**URGENT: FIELD SAFETY NOTICE – MMS-19-1572**

T34™ and T34L™ (T60™) Ambulatory Syringe Pumps

Type of Action: Advisory Notice

**Figure 1: Lead Screw & white plastic debris**

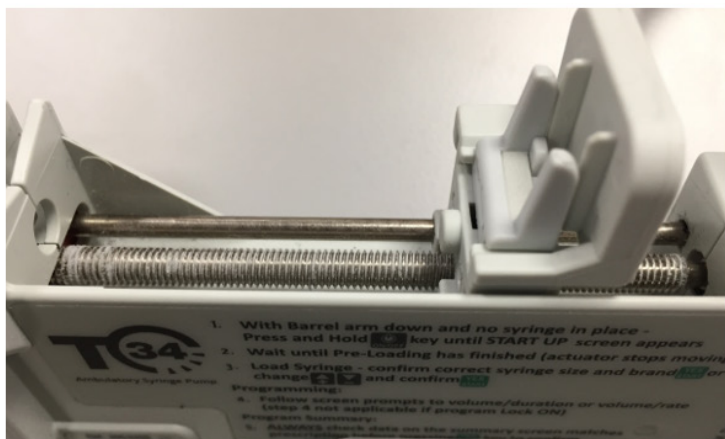
The issue can be observed when the actuator does not move when the lead screw is rotating, resulting in potentially no pressure on syringe plunger to deliver the syringe contents. The cause of this issue is the actuator nut being worn enough to stop or lose traction on the lead screw due to irregular coating of the actuator. The “wear / tear” effect can be visually observed as the lead screw is progressively wearing the plastic actuator nut overtime, leaving white plastic debris along the lead screw (see Figure 1 below).

Inspect the lead screw prior to use (See 3.2 Pump Description, item 4). If there is white plastic debris on the lead screw, this is an indication of wear on the syringe mechanism. Therefore, discontinue use and send the pump for service.
